## PLANNING COMMISSION MEETING

**RE: Ginko Self Storage -Final Site Plan/Final Engineering Plan Review-3<sup>rd</sup> Review  
Stormwater Maintenance Agreement Review-1<sup>st</sup> Review**

## Revised Final Site Plan Review for Special Land Use for White Lake Charter Township, Michigan

# GINKO SELF STORAGE

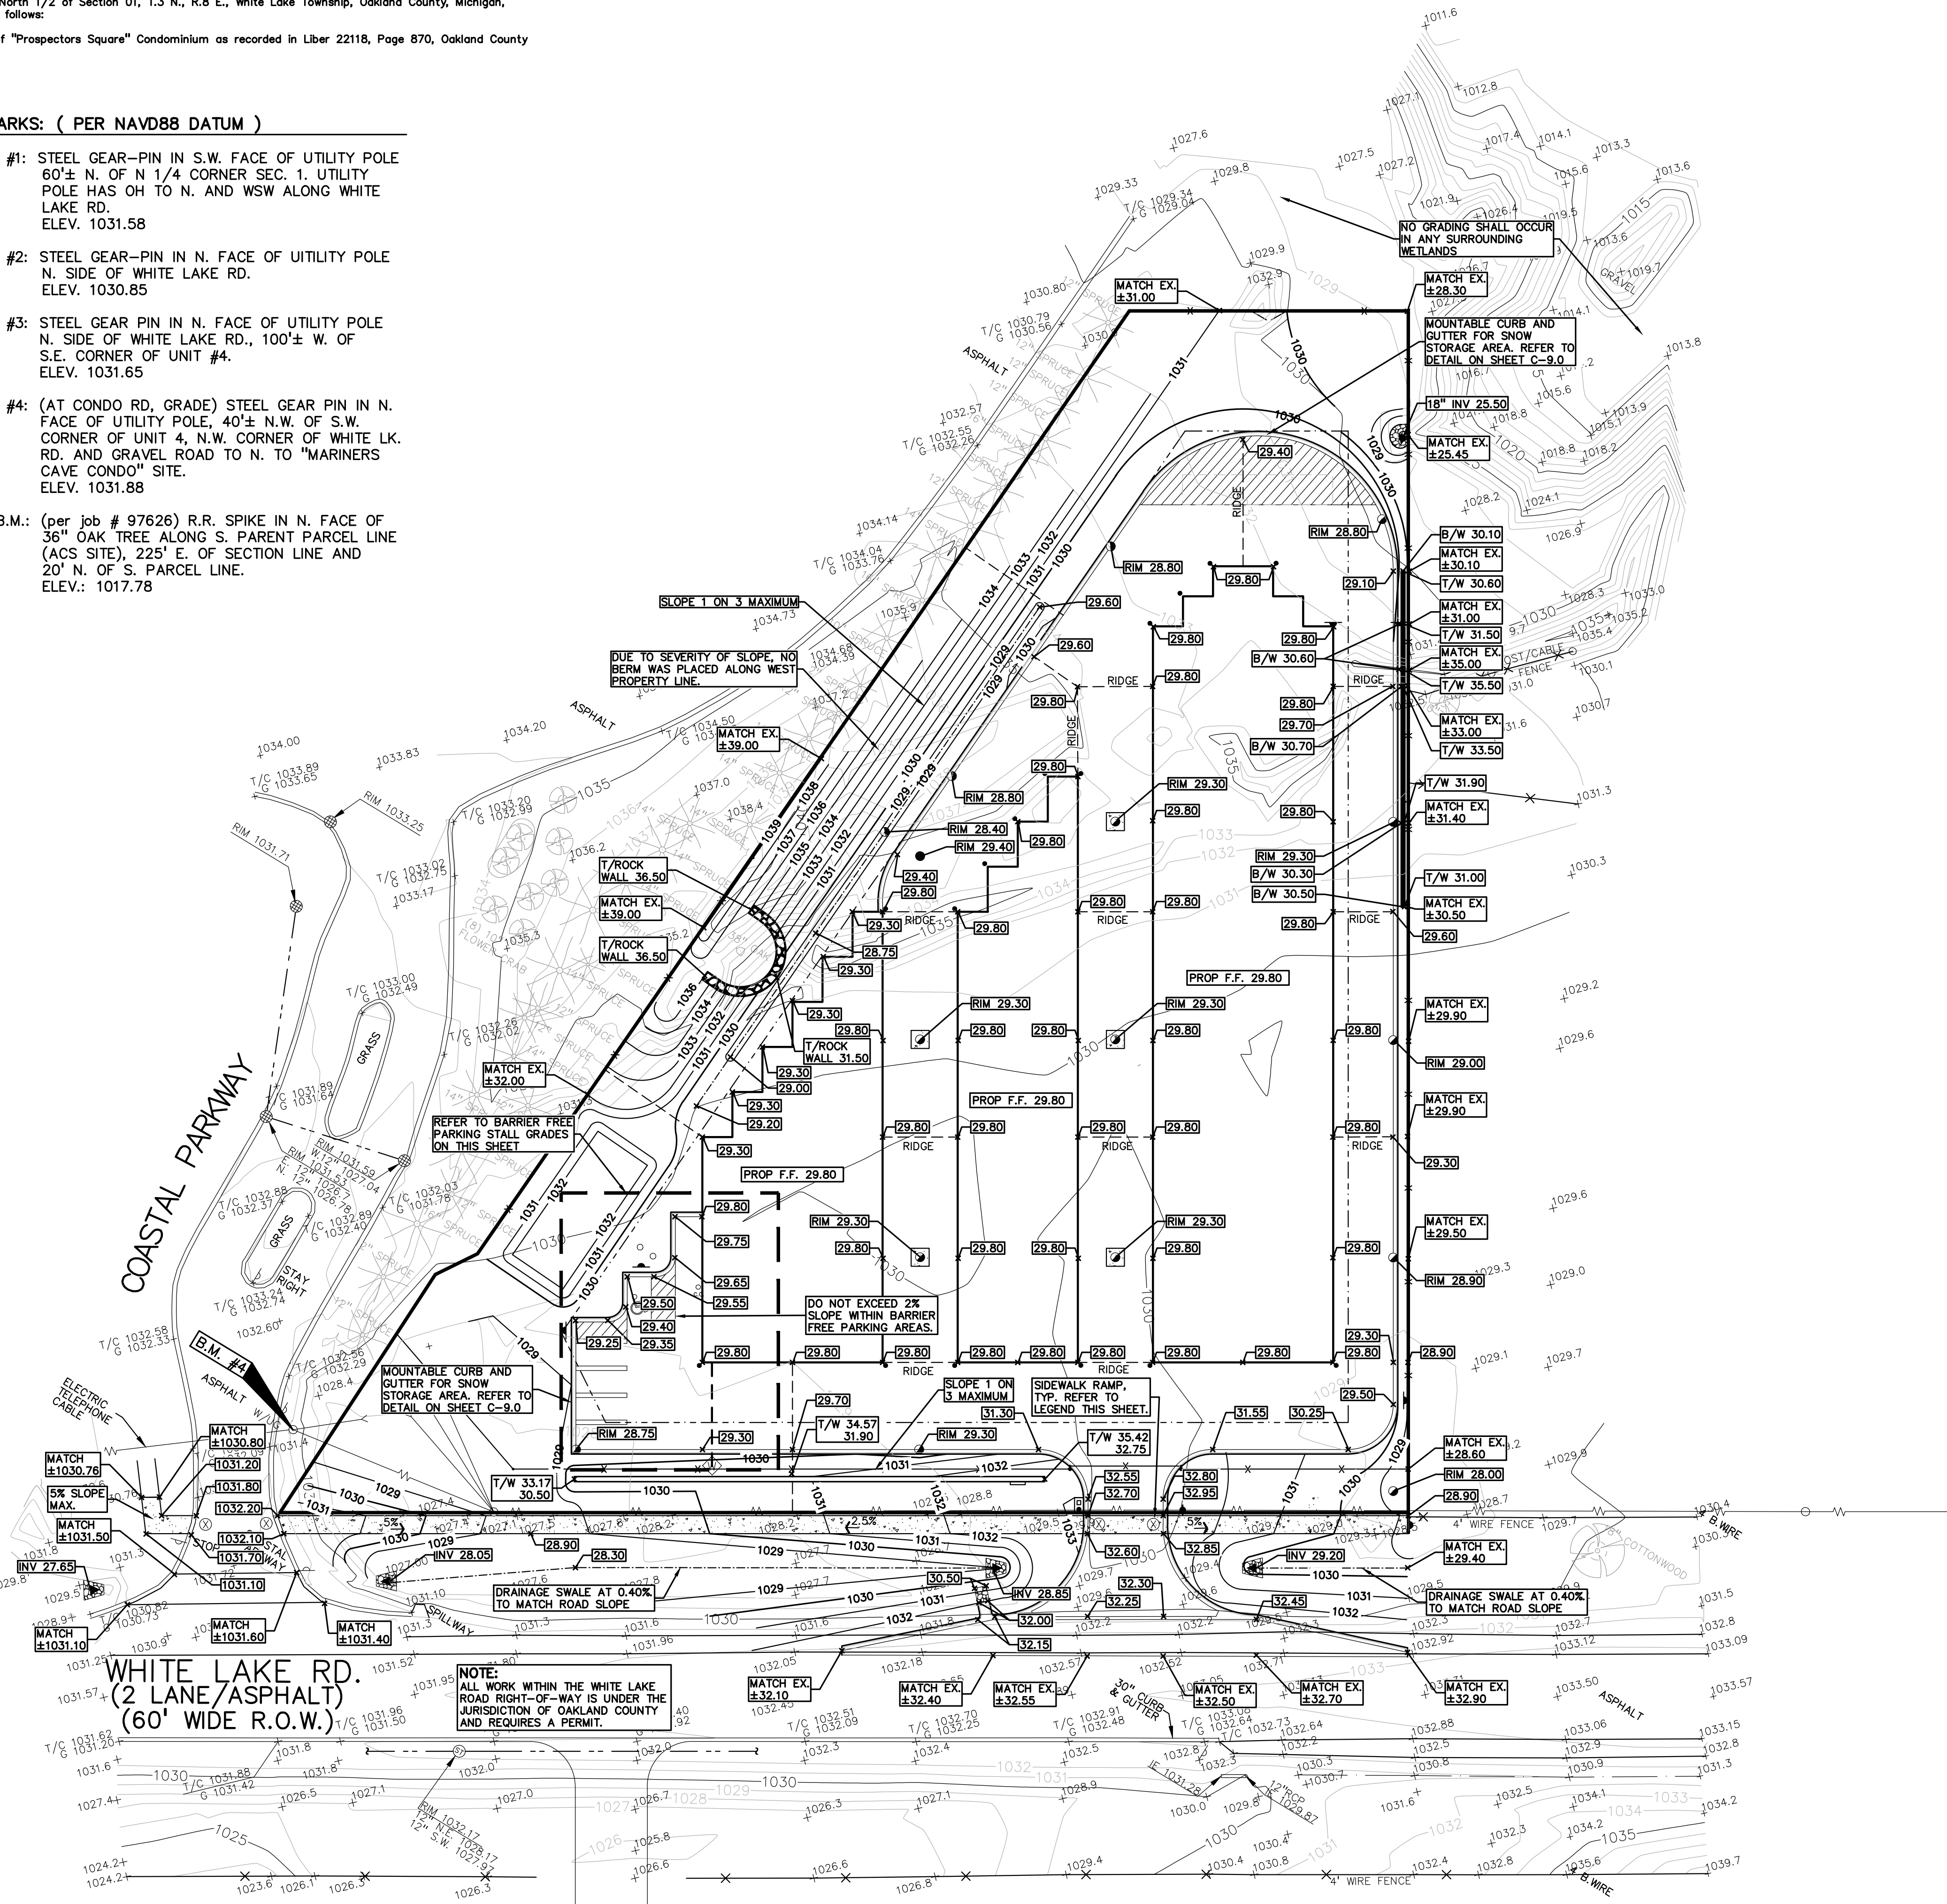
6. *Sheet C-4.0- SE corner of site at 'Match EX. +- 28.60'. This is a low point; the proposed road ditch grading as shown will not function properly as drainage from the Match EX +-29.40' grade will flow toward the low point of 28.60. In addition, drainage from the north and north west shall also collect and pond at this low point. Please revise.* **Comment partially addressed. A storm structure has been added at the low point to collect the drainage that would collect in this area; however, please show/shade in storm piping on Sheet C-6.0.**

7. *Sheet C-4.0- There is a low point of 32.45 along the eastern drive entrance. We recommend a spillway be provided to route the drainage into the ditch. In addition, there is a low point (32.25) in the Detail M gutter.* **Comment addressed. Grades have now been revised for positive drainage and a spillway to route the drainage to the ditch has now been provided.**

8. *Sheet C-4.0- Provide TW and BW grades for the eastern end of the dry laid fieldstone wall.* **Comment addressed. The grades have been provided.**
9. *Sheet C-4.0-It appears that the grading will be too steep (at the 31.30 asphalt grade near eastern end of fieldstone wall/berm) from top of curb elevation (31.80) to the 1030 berm contour. Please revise as needed.* **Comment addressed. Grades have been revised to reduce the slope. In addition, a note has been added to this area indicating that the slope in this area shall be a 1:3 maximum.**

10. *Sheet C-4.0- Invert grade of ES17 (28.85) will result in ponding of water at this elevation as the adjacent ditch contour to the west (1029) will act as a high point. Please revise.* **Comment addressed. Adjacent ditch contour has been adjusted to minimize ponding in this area.**

11. *Sheet C-4.0-Clarify what the 'Xs' are for at the Coastal Parkway and Ginko entrance sidewalk crossings.* **Comment addressed. 'Xs' are for a Type R sidewalk ramp.**

12. *Sheet C-4.0- Provide existing grades for Coastal parkway sidewalk. Currently note says 'Match Ex.'* **Comment addressed. Existing grades have been provided.**

13. *Sheet C-4.0- There is a low point in the sidewalk at 1028 and this grade sits lower than the adjacent proposed ditch grades of 1028.30 and 1028.05. Please revise for positive drainage. **Comment addressed. Sidewalk grade has been revised for positive drainage.***

14. *Sheet C-4.0- It appears that drainage will pond in a flat area on the south side of the proposed berm before it will head west. Please revise grades here for positive drainage. **Comment addressed. Grading has been revised for positive drainage.***

DRAWING NUMBER:  
**C-5.0**

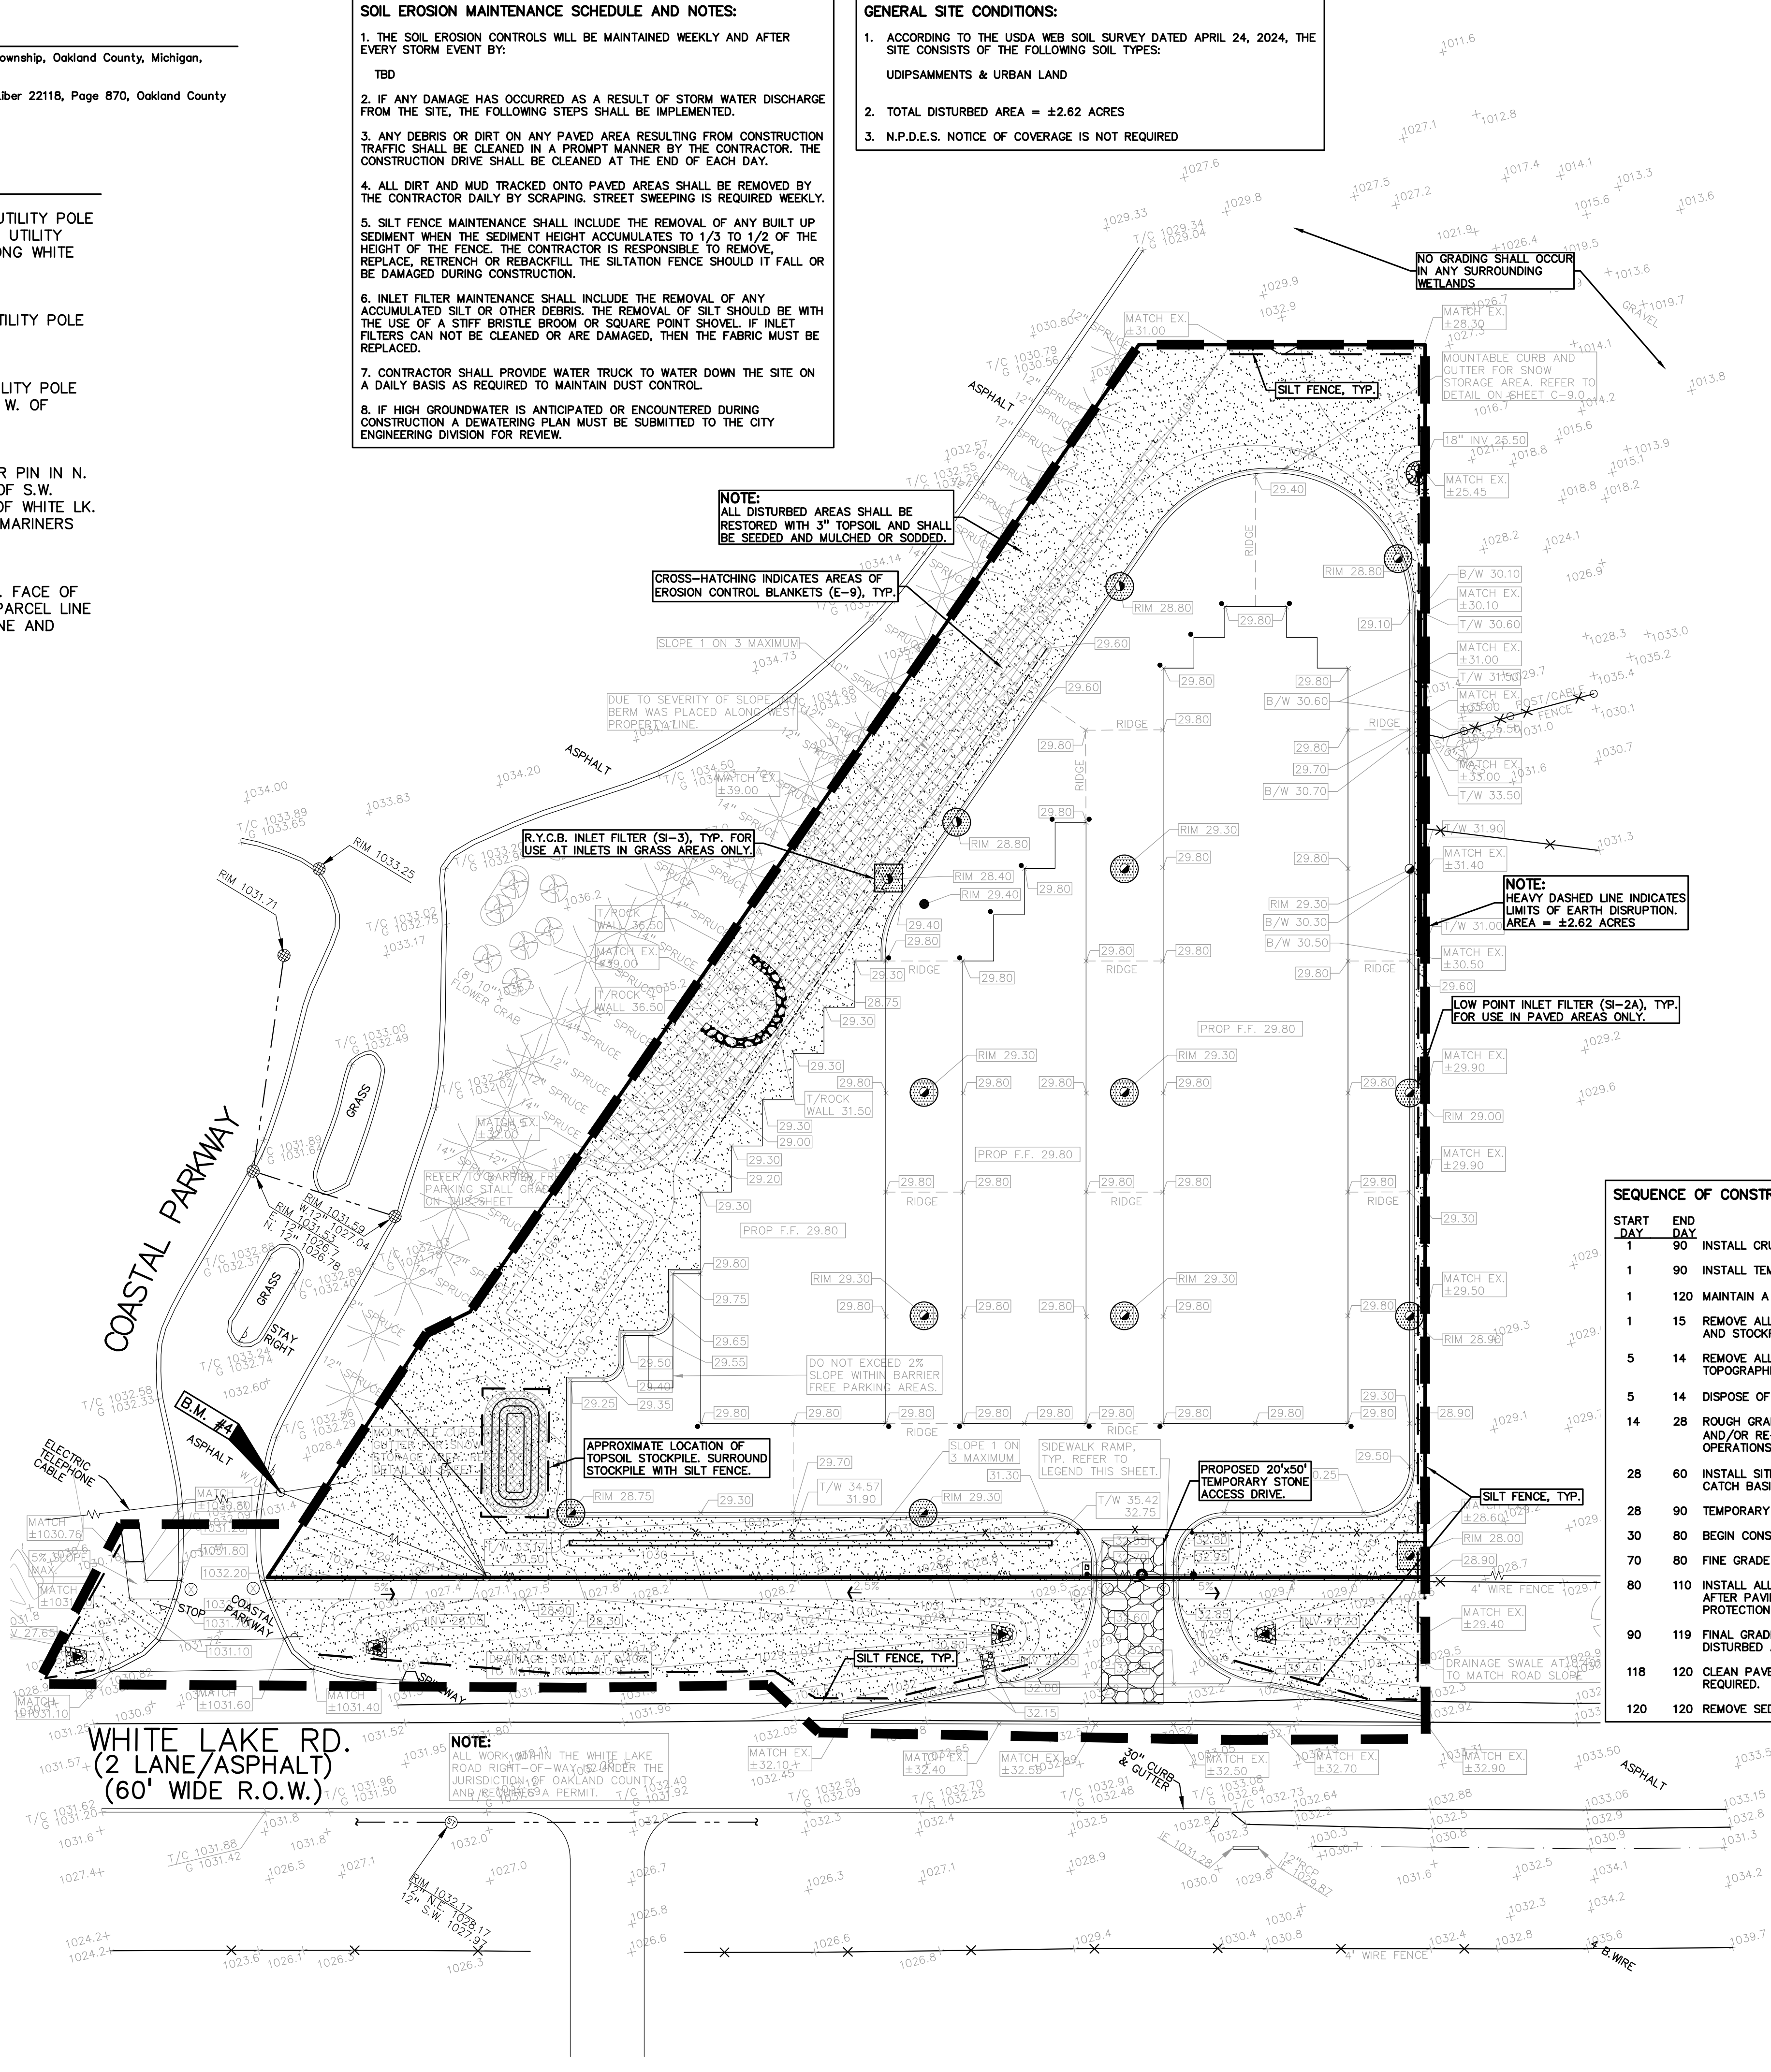
15. *Sheet C-5.0- We note that there are several grades shown on this sheet that do not match the grading plan. Example: Grade 1029.50 adjacent to topsoil stockpile does not match grade of 1029.70 shown on Sheet C-4.0. Please double check and revise grades on the SESC plan such that they match those on Sheet C-4.0. **Comment addressed. Grades on SESC plan now appear consistent with Sheet C-4.0.***
